Date Issued:	June 30, 2020
Project Name:	CUP #20-02, Darigold
Applicant:	John Kay, Agent, Magellan Architects
Property Owner:	Darigold
Site Address:	8455 Depot Road, Lynden
Parcel Number	400320-249485
Zoning Designation:	ID
Application Type:	Conditional Use Permit (CUP)
Parcel Size:	N/A
Hearing Type:	Quasi-Judicial
Hearing Objective:	The objective of this public hearing is to determine whether the proposed Conditional Use Permit meets the criteria found within Section 19.49.020 of the Lynden Municipal Code.
Date application determined complete:	June 11, 2020
Date of Publication:	June 24, 2020
SEPA Determination:	June 19, 2020
Project Description:	The applicant is requesting a conditional use permit to exceed the height limitation of 60-feet to 70-feet 6 inches tall to contain milk processing equipment.

CUP# 20-02
PLN 00306

Conditional Use Permit Application

BUILDING ELEVATIONS
A1.03

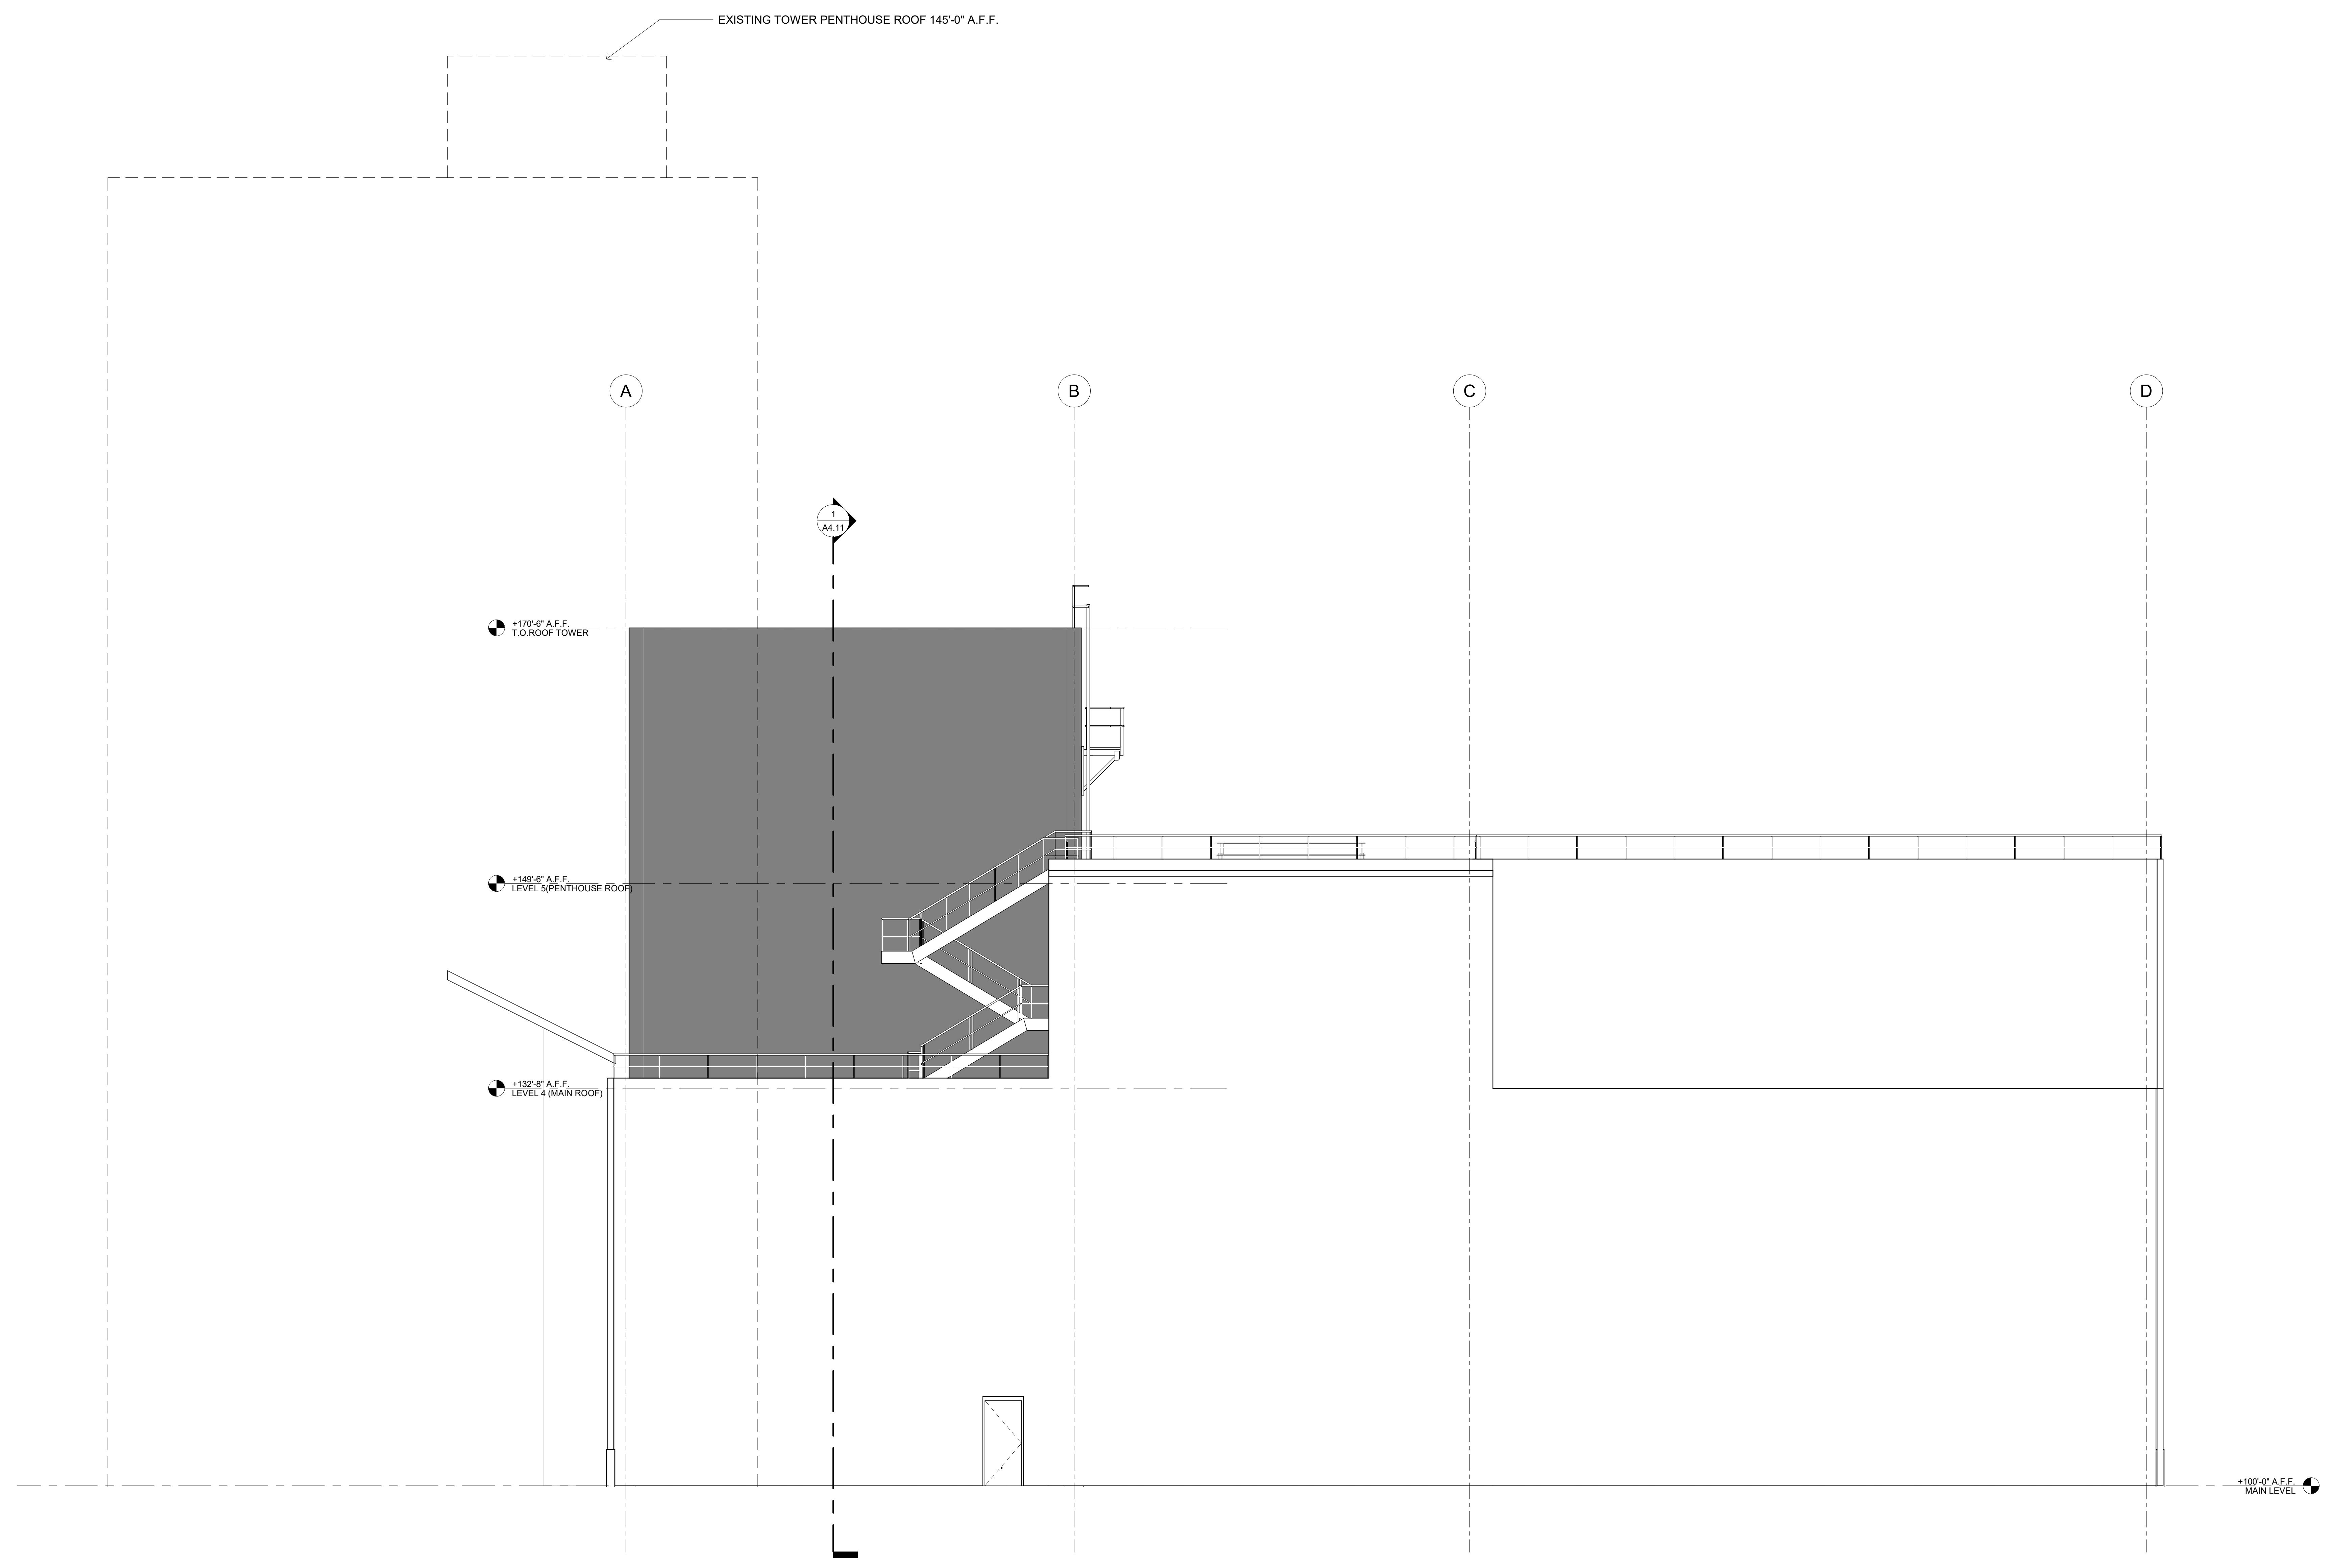
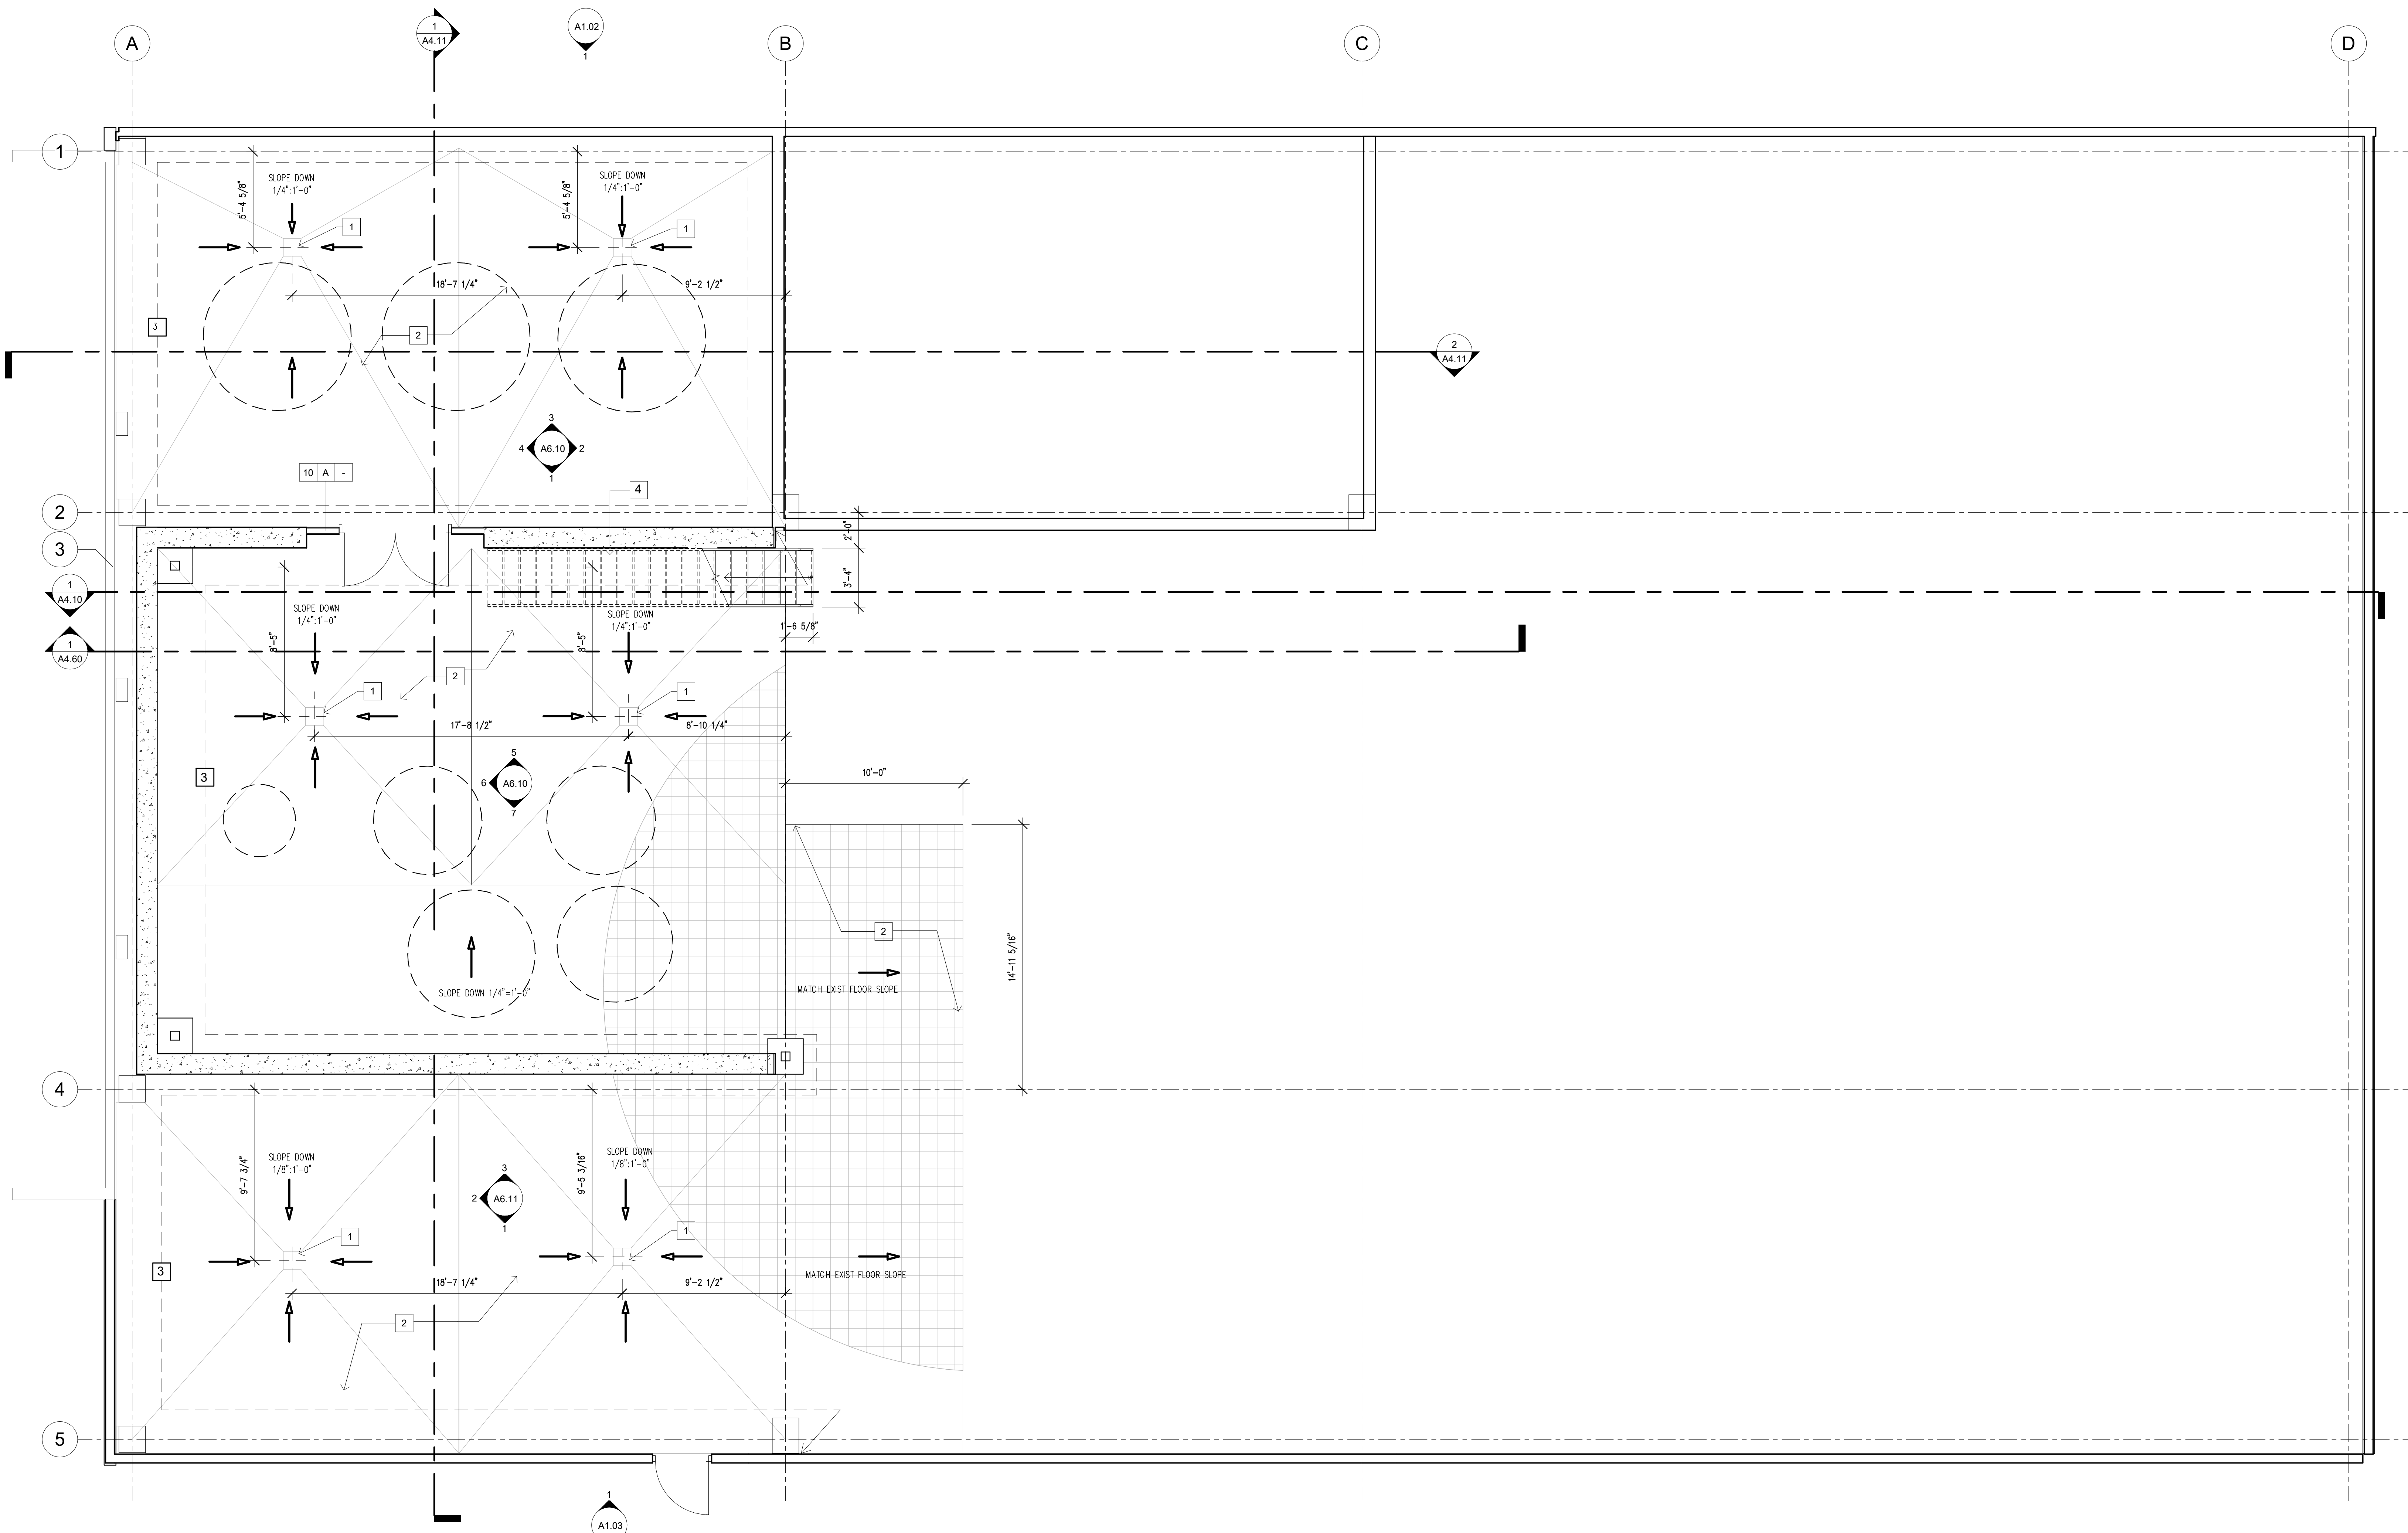
3. *Architecture:* Staff recommends that the Permit be conditioned to include a requirement that the color and materials of the new tower be compatible with that of the existing concrete tower to create a consistent, unobtrusive appearance.
